NOTICE OF PUBLIC HEARING
Minor Variance

APPLICATION NO.:	A-25:169	SUBJECT PROPERTY:	29 Berry Hill Avenue, Flamborough
ZONE:	'P6' (Conservation / Hazard Land - Rural Zone)	ZONING BY-LAW:	Hamilton Zoning By-law 05-200, as Amended by By-law 15-173

RE: ZONING BYLAW COMPLIANCE REVIEW – IN SUPPORT OF A MINOR VARIANCE APPLICATION
PRESENT ZONING: Conservation / Hazard Land Rural (P6) Zone
ZONING BY-LAW: City of Hamilton Zoning By-law 05-200
ADDRESS: 29 Berry Hill Avenue, Flamborough

FRONT ELEVATION
(SOUTH)

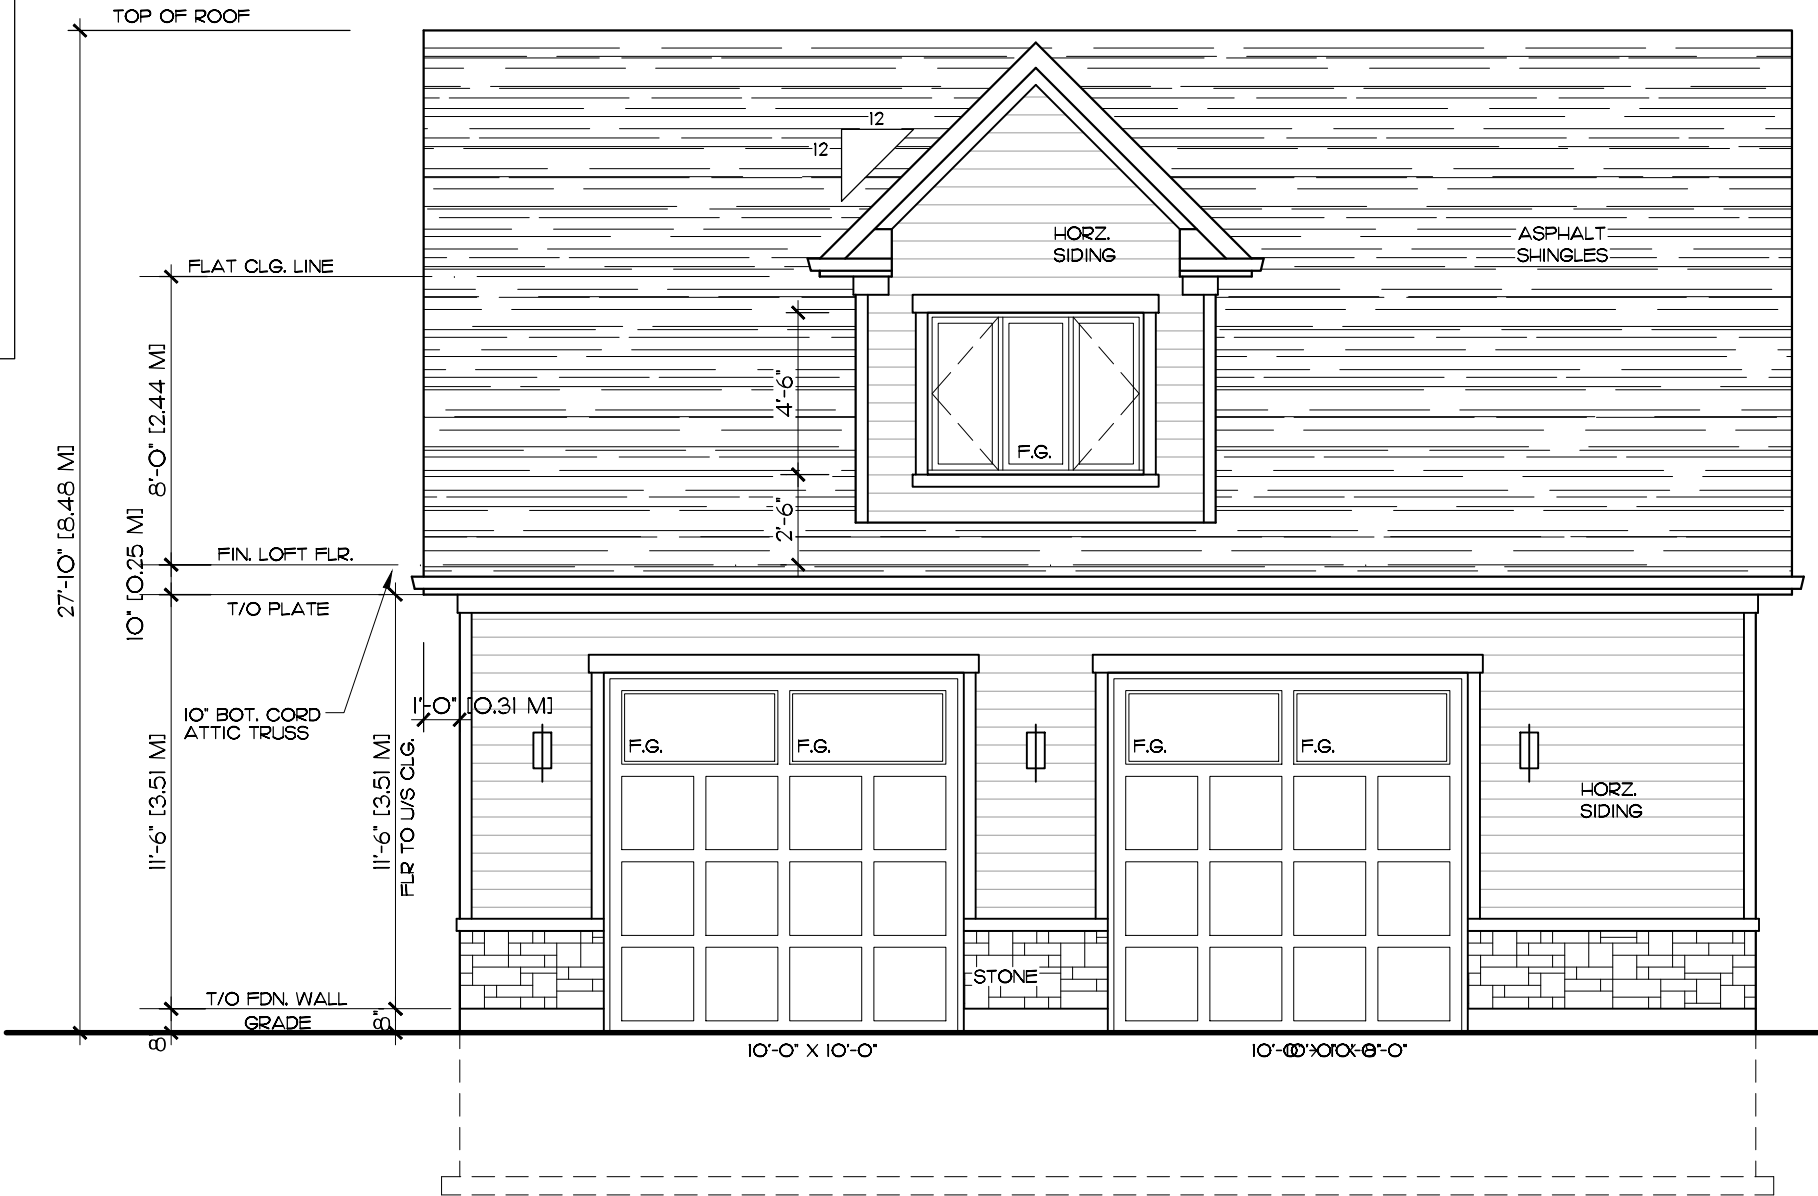
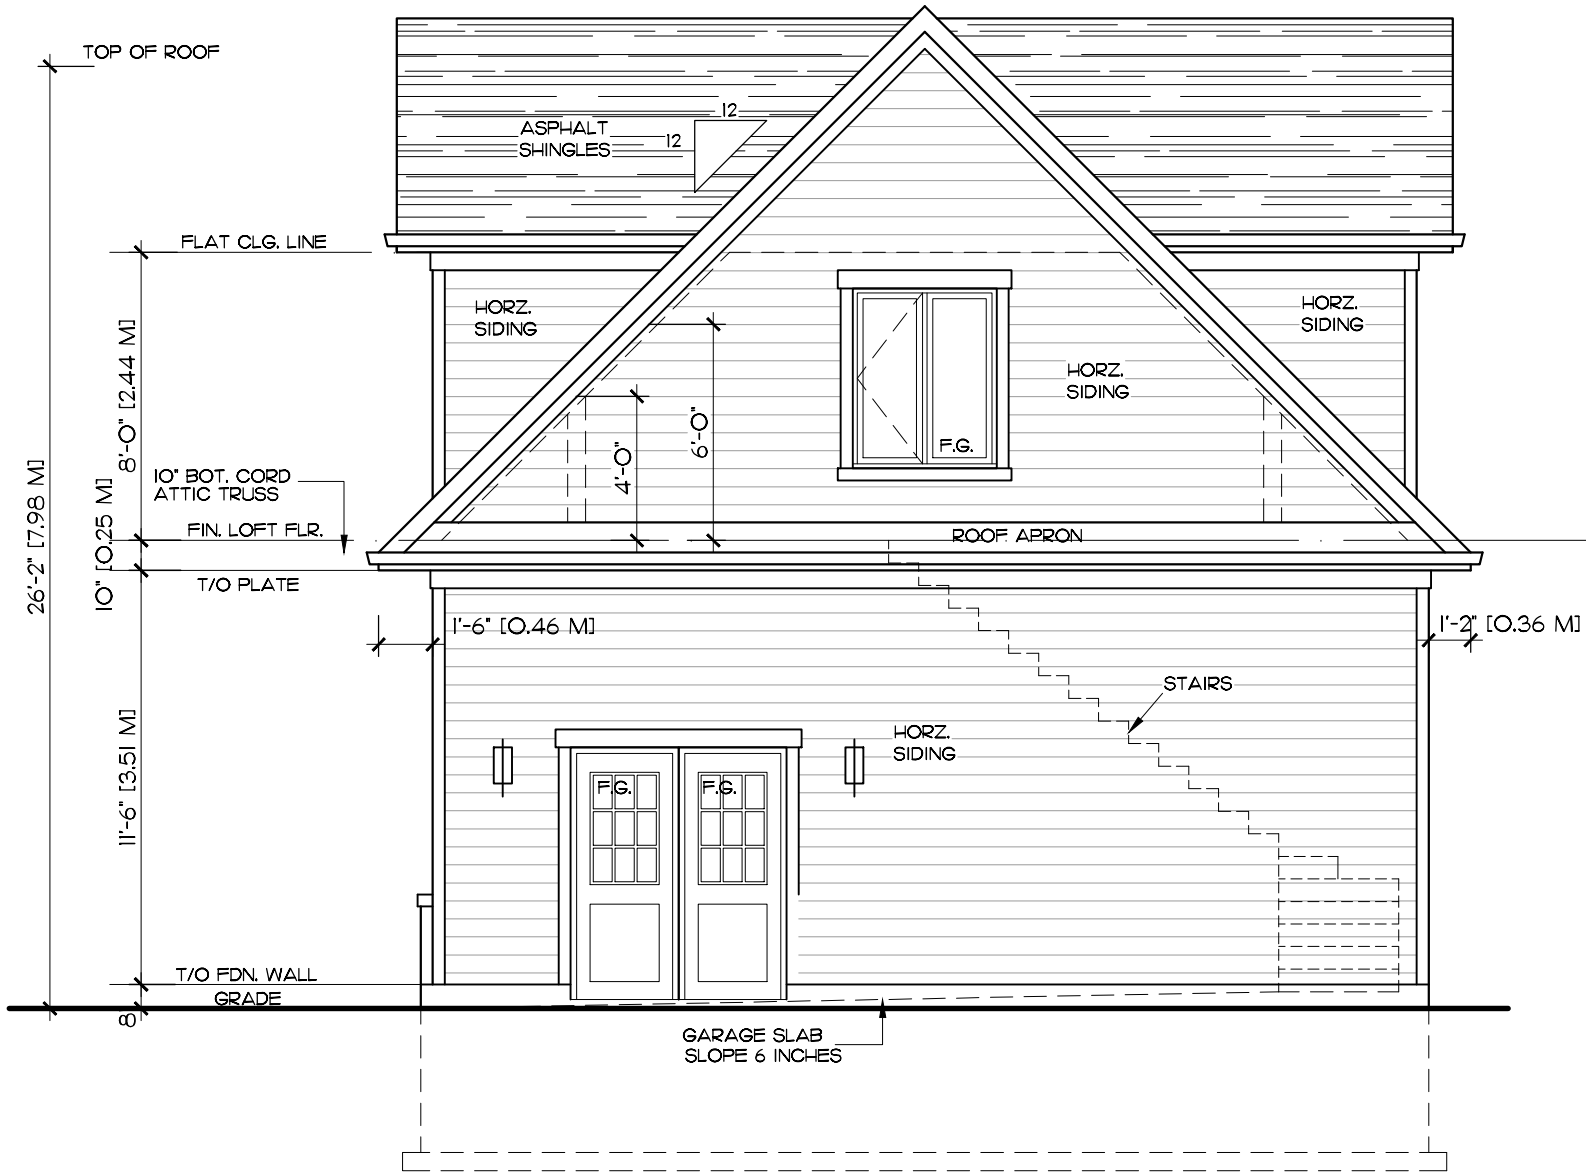
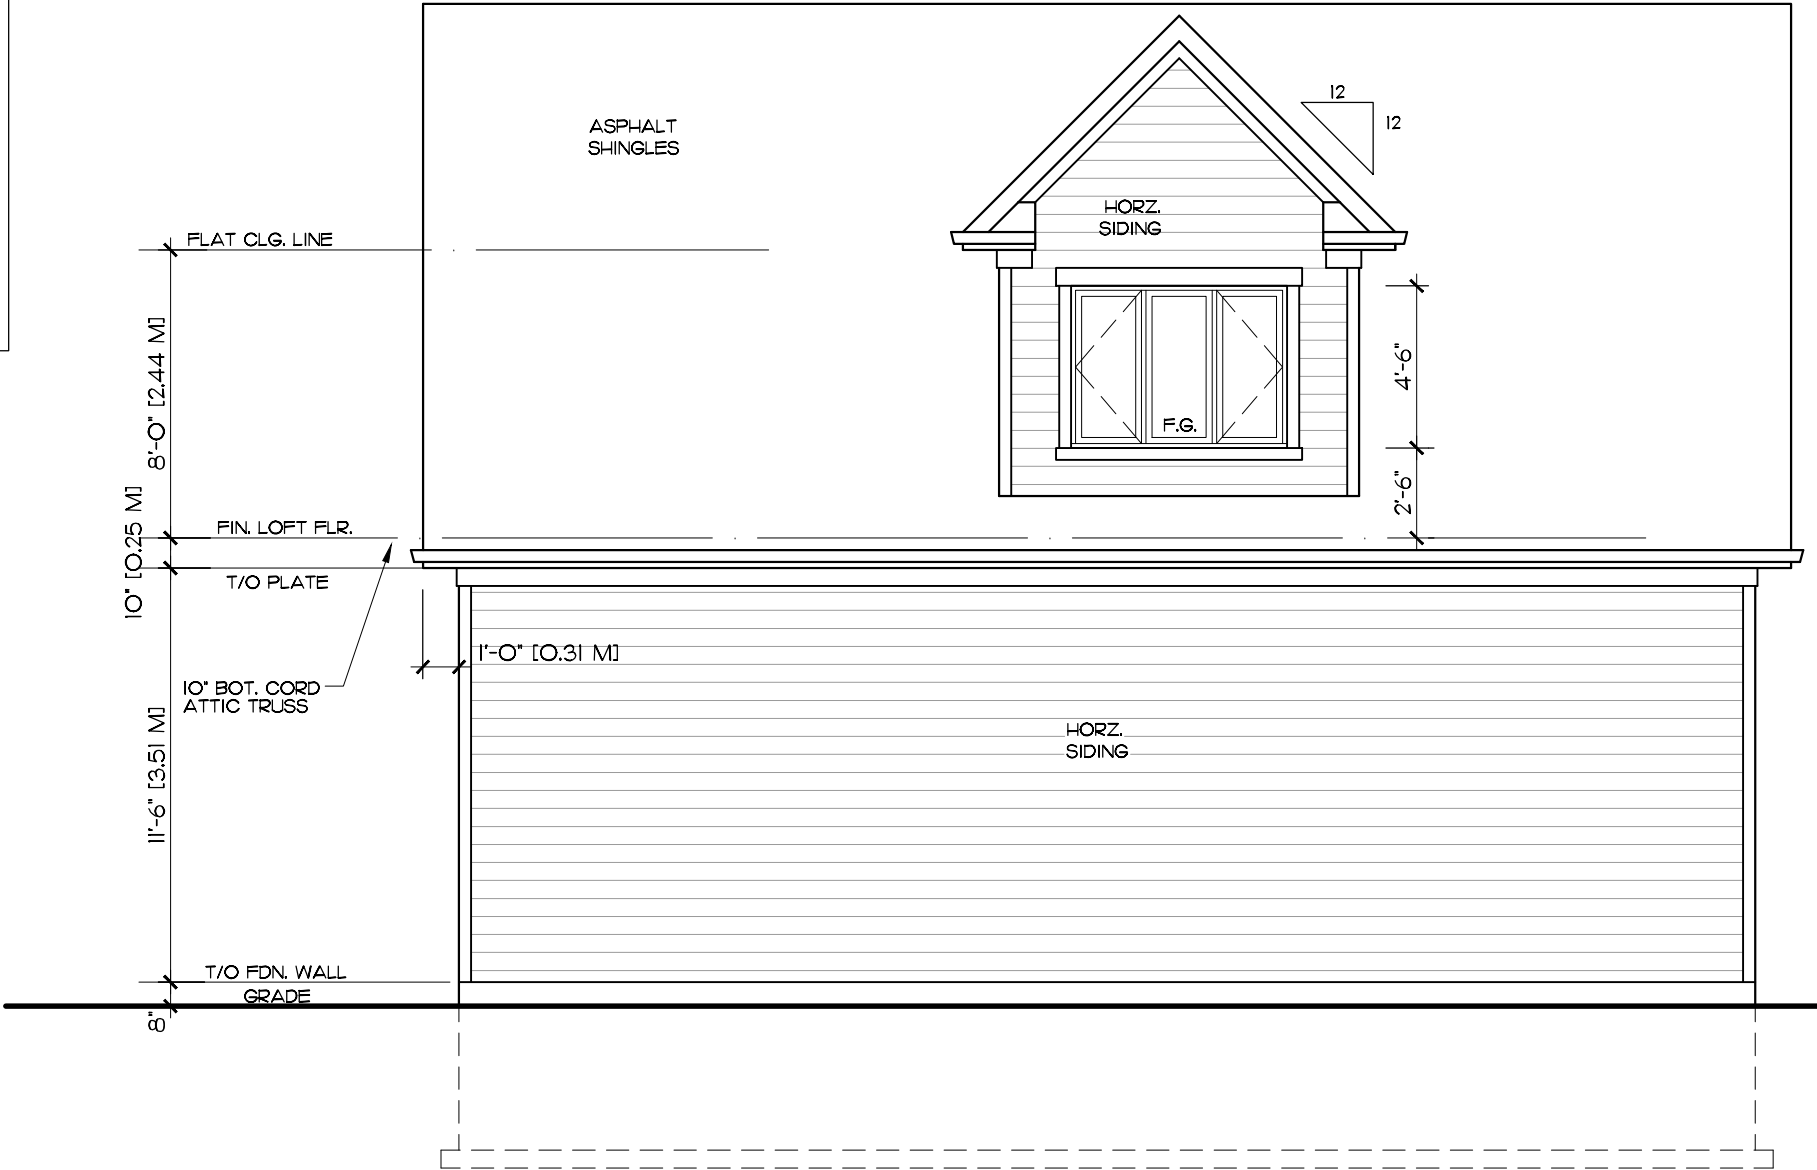
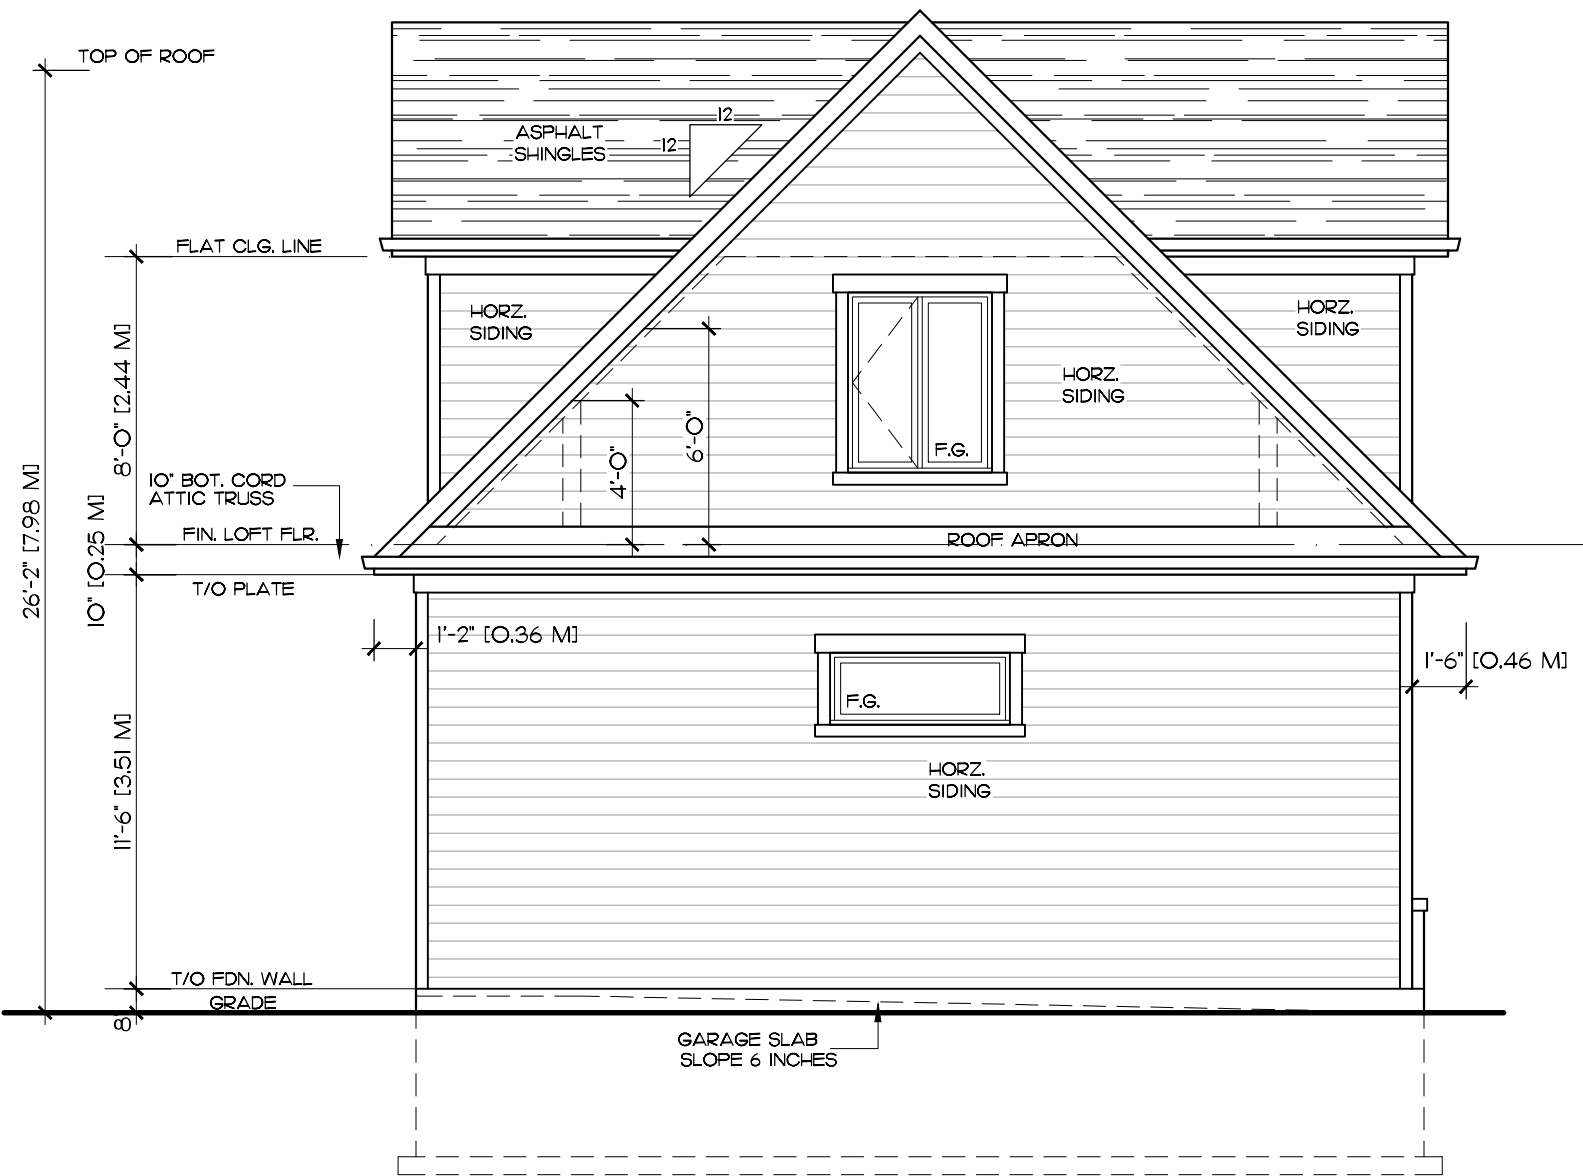
Where a Zone contains a Maximum Setback [as per section 4.8 d) of Hamilton Zoning By-law 05-200]	Notwithstanding any other provisions in this By-law, where a zone contains a maximum setback requirement from a street line, the maximum setback requirement shall not apply to Accessory Buildings.	Not Applicable.	N/A
Maximum Building Height [as per section 4.8 g) of Hamilton Zoning By-law 05-200]	All Accessory Buildings shall have a maximum height of 4.5 metres. <u>Note:</u> Building Height - shall mean the vertical distance from grade to the uppermost point of the building but not including any mechanical penthouse or any portion of a building designed, adapted or used for such features as a chimney, smokestack, fire wall, stair tower, fire tower, water tower, tank, elevator bulkhead, ventilator, skylight, cooling tower, derrick, conveyor, antenna, or any such requisite appurtenance, or a	Based on the Front Elevation – South (Drawing D04), the proposed building height is 8.48m – measured from grade to the top of roof.	Non-Conforming
